**BCA & DDA/ACCESS ASSESSMENT REPORT**  
*Design Development Report*

**PROJECT:**  
**GUNNEDAH HOSPITAL REDEVELOPMENT**  
*Stage 1*

Date: 9 June 2023

Figure 65

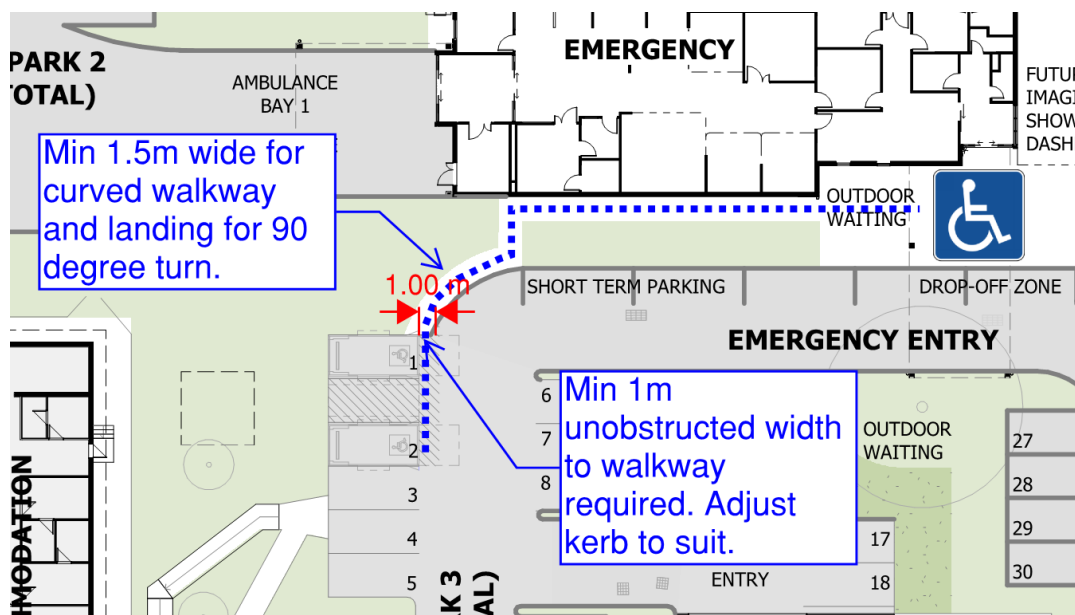
Emergency entry path required any gradient to be confirmed on plan. Curved walkways and ramps are required to be minimum 1.5m as is landing for turns no greater than 90 degrees. The walkway is to permit minimum 1m clear unobstructed access from shared zone to accessway.

Figure 67

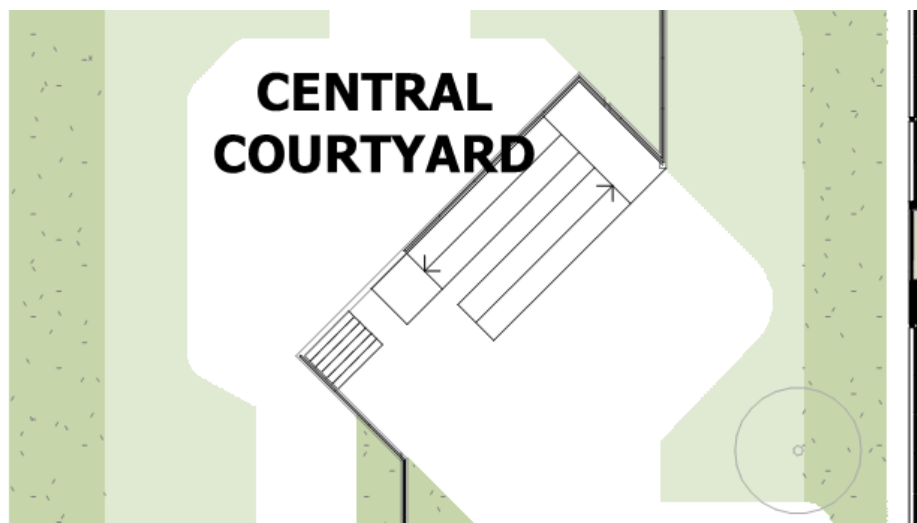
Additional details are to be provided for landscaped forecourt ramp/ walk demonstrating compliance with AS1428.1. This includes handrails both sides, TGSi, grade depicted on ramp and turn space for 180 degrees to be marked on plan.

Figure 68

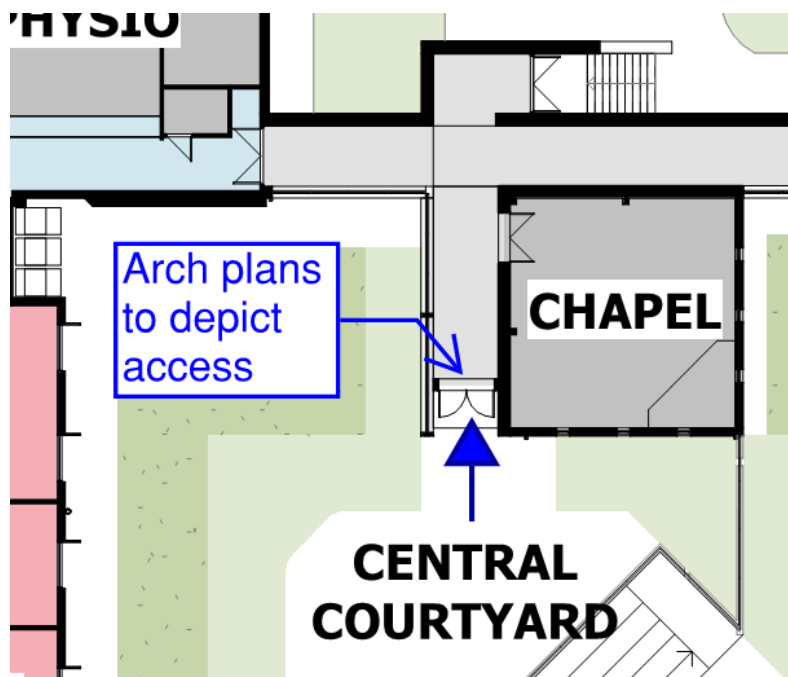
Confirmation required how new chapel entry will require with DDA requirements. The path is required to be accessible including smooth and level door threshold. Confirm on plans if ramp is required, dual leaf doors require at least one leaf to be min 850mm (920mm door).

Figure 83

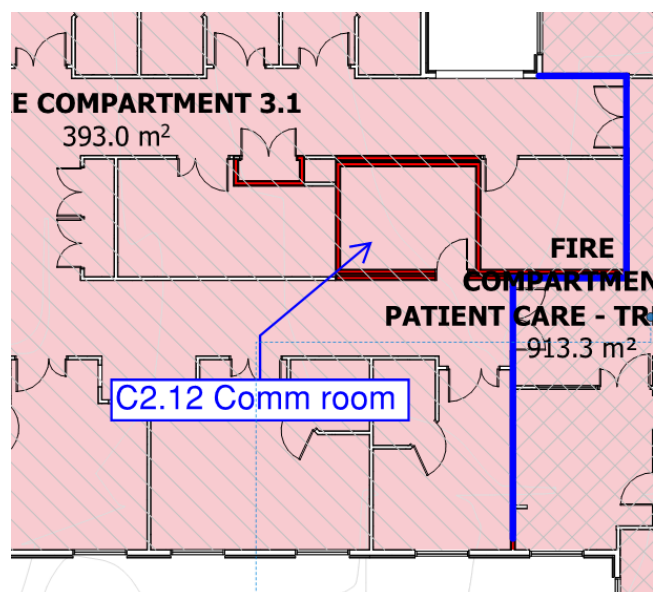
Fire hose reels are not permitted to pass through fire or smoke door except where permitted by BCA E1.4 (F). Typical example below of room FHR cupboard is permitted to pass through below.

Figure 84

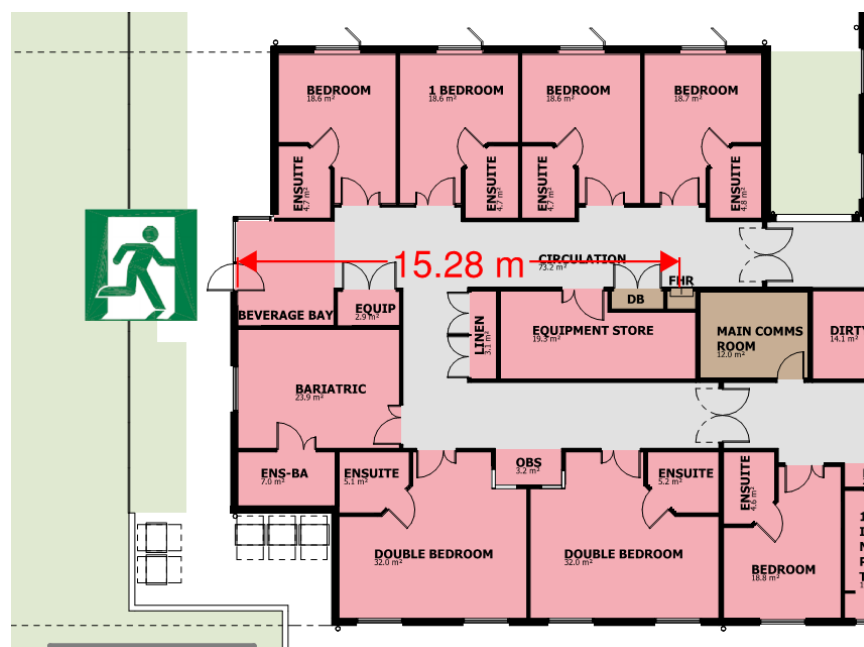
Typical below rectify in all areas where this occurs.

Figure 88

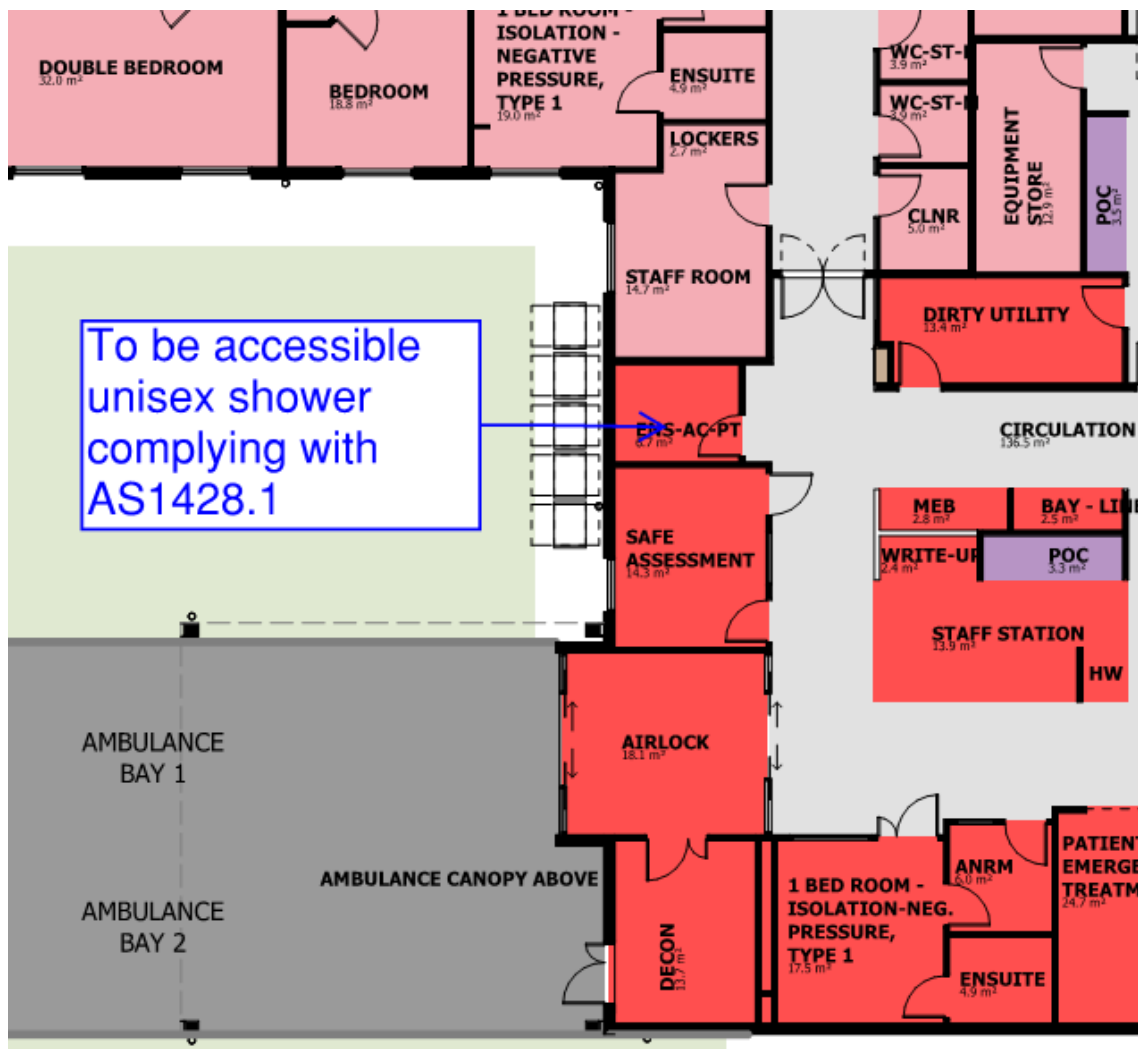
The new treatment area has single accessible ensuite only. Treatment areas require 1 x shower per 8 patients. Confirm shower provision within and no more than 8 patients within treatment compartment. See F2.4 for accessible unisex requirement.

Figure 92

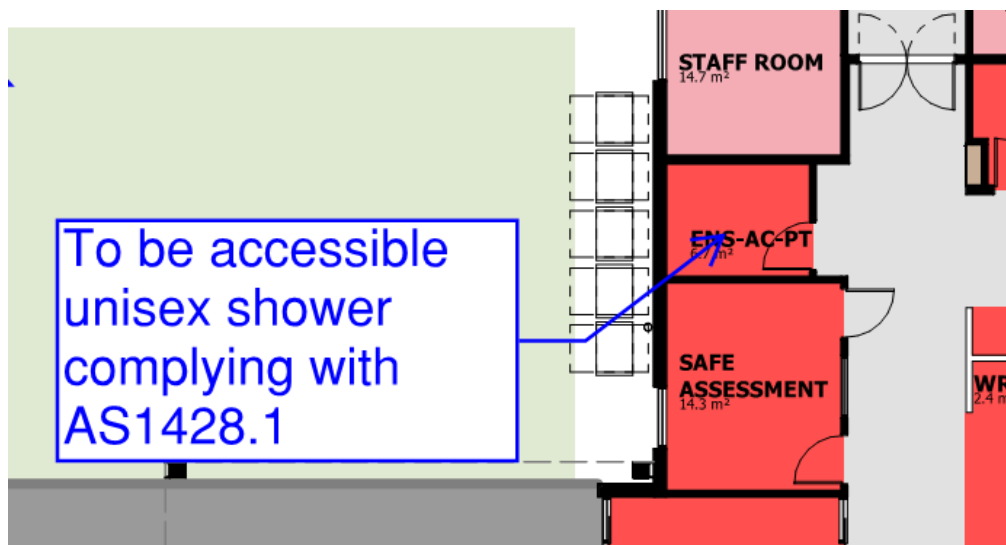
The new treatment area requires an accessible unisex facility for patients (male and female) and a shower to serve no more than 8 patients. Plans to be updated to confirm accessible unisex sanitary facility and shower in

accordance with AS1428.1. Confirm if more than 8 patients in treatment.
